APPLICATION NO.	FILING DATE	FIRST NAMED INVENTOR	ATTORNEY DOCKET NO.	CONFIRMATION NO.
09/864,389	05/25/2001	Jacob Richter	2390/49704	1194
27123	7590	01/12/2005	EXAMINER	
MORGAN & FINNEGAN, L.L.P. 3 WORLD FINANCIAL CENTER NEW YORK, NY 10281-2101			BUI, VY Q	
			ART UNIT	PAPER NUMBER
			3731

<b>Office Action Summary</b>	Application No. 09/864,389	Applicant(s) PINCHASIK ET AL 	
	Examiner Vy Q. Bui	Art Unit 3731

DETAILED ACTION

*Fig. 30*

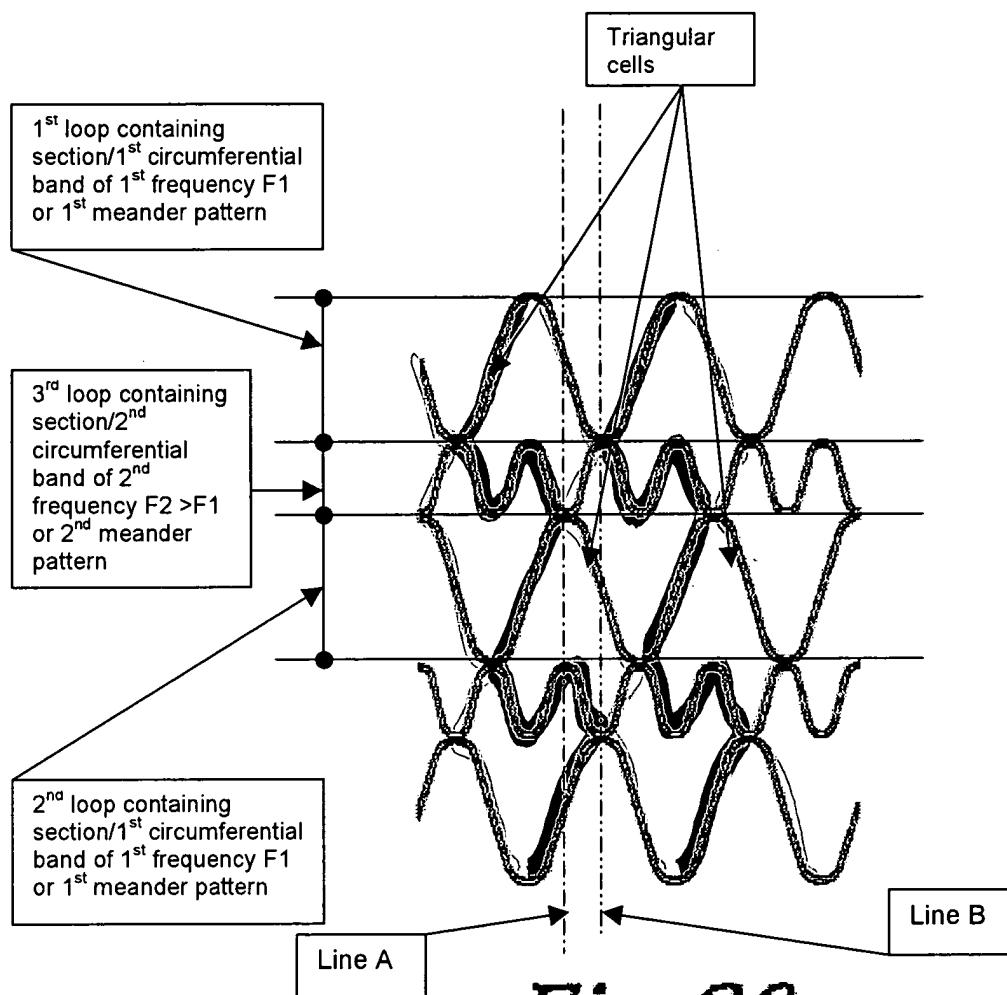
As to claims 1-2, 4, 6-7, 11-12, 14, 16-17, 19, 42-47, 49 and 50-51, JAYARAMAN (see Fig. 30 on page 3 above) shows a stent structure comprising 1<sup>st</sup> and 2<sup>nd</sup> loop containing sections/1<sup>st</sup> circumferential bands/1<sup>st</sup> meander pattern of a 1<sup>st</sup> frequency F1, 3<sup>rd</sup> loop containing sections/2<sup>nd</sup> circumferential bands/2<sup>nd</sup> meander pattern of 2<sup>nd</sup> frequency F2 > F1 to define cells/triangular cells as recited in the claims.

a. 3<sup>rd</sup> loop containing sections are configured in a sinusoidal shape of a frequency F2 higher than a frequency F1 of 1<sup>st</sup> and 2<sup>nd</sup> loop containing sections (Fig. 30, page 3 above), therefore 3<sup>rd</sup> loop containing sections do expand or contract when the stent structure is bent/expanded, thus 3<sup>rd</sup> loop containing sections do contribute to the cells elongating or

shortening when the stent is in a curved configuration/expanded configuration. In addition, because the 3<sup>rd</sup> loop containing sections have more stored length (or more springy/wavy than 1<sup>st</sup> and 2<sup>nd</sup> loop containing sections), the 3<sup>rd</sup> loop containing sections are more flexible and more sensitive to deformation than 1<sup>st</sup> and 2<sup>nd</sup> loop containing sections, therefore during flexing of the stent, 3<sup>rd</sup> loop containing sections contribute more to the stent deformation than 1<sup>st</sup> and 2<sup>nd</sup> loop containing sections.

b. Cells/triangular cells in one side of a neutral axis of bending of the JAYARAMAN stent will be in a tension condition and in the other side of the neutral axis will be in a compression condition. Cells under the tension condition will open in length and narrow circumferentially and cells under the compression condition will shorten in length but widen circumferentially.

c. In an collapsed configuration for deployment/before expansion, lines A and B are substantially closed one to another to make two low frequency adjacent bands out of phase 180° as recited in the claims.

d. Fig. 30 shows vertical meander patterns and horizontal meander patterns as recited in the claims.

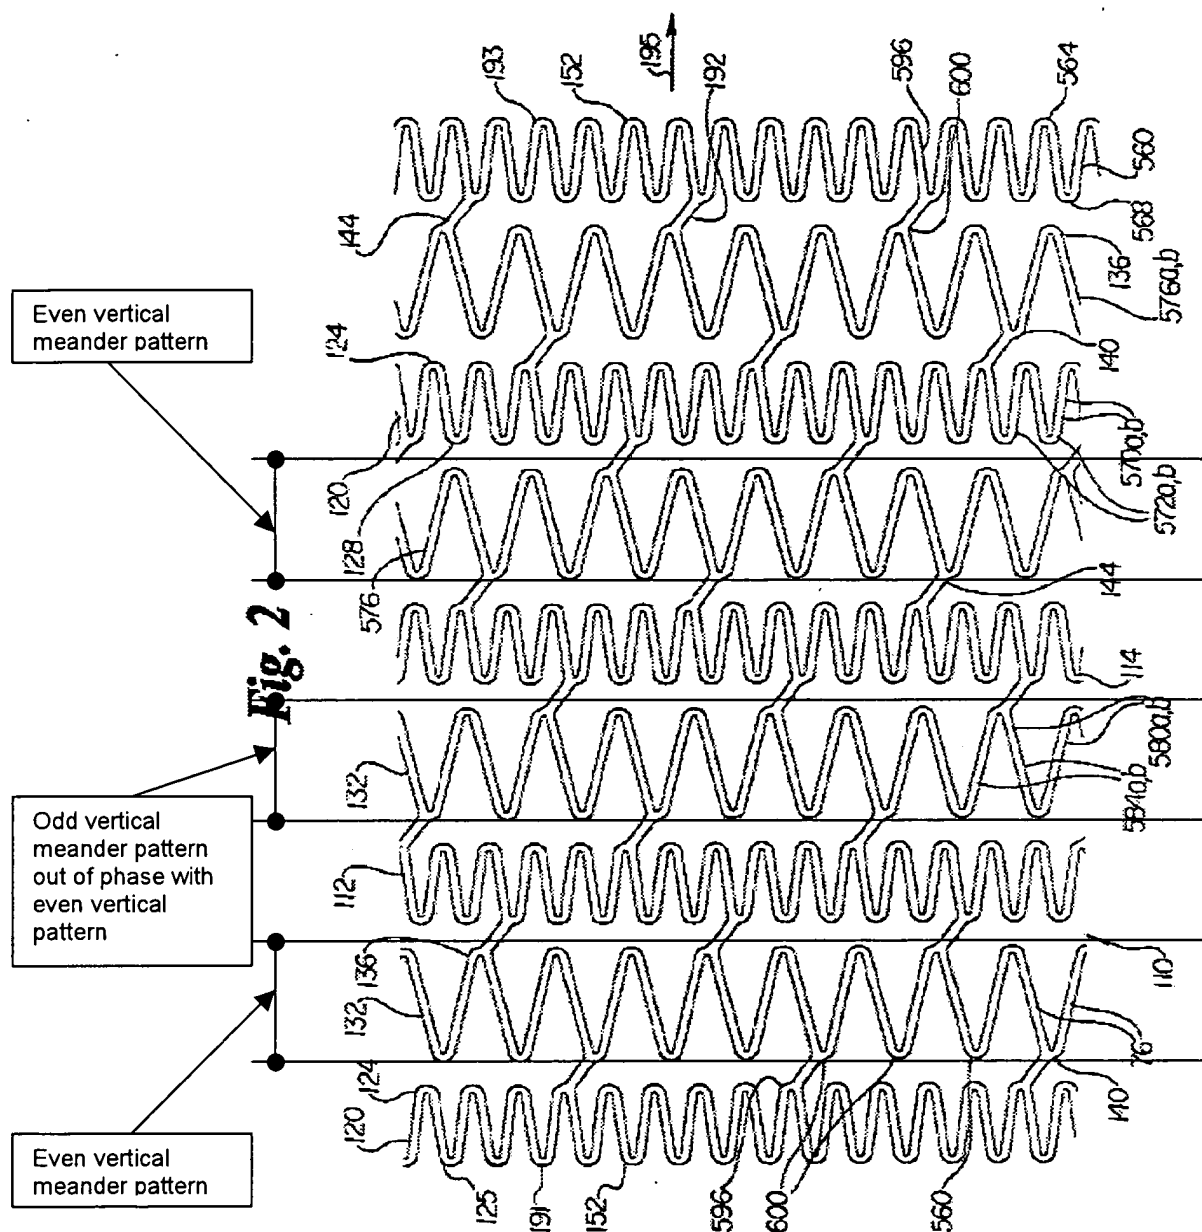
As to claims 21-22, 24, 48-49, BROWN (Fig. 2, page 5, this paper) shows even 1<sup>st</sup> meander patterns substantially are 180 degree out of phase with odd 1<sup>st</sup> meander patterns, especially when the stent is squeezed in a collapsed configuration for deployment in a blood vessel before expansion. Even 1<sup>st</sup> and odd 1<sup>st</sup> meander patterns alternate with and are spaced from each other to form a uniform flexible structure as recited in the claims. When expanded in

a curved vessel, BROWN shows cells that increase in length in one side of a neutral axis/bending axis and cells that decrease in length in another side of the neutral axis.

As to claim 26-27 and 29, notice that BROWN stent (see Brown's Fig. 2) comprises many flexible triangular cells to form a uniform mesh of flexible cells. When expanded in a curved vessel, BROWN triangular cells will increase in length in one side of the neutral axis and decrease in length in one side of the neutral axis as recited in the claim.
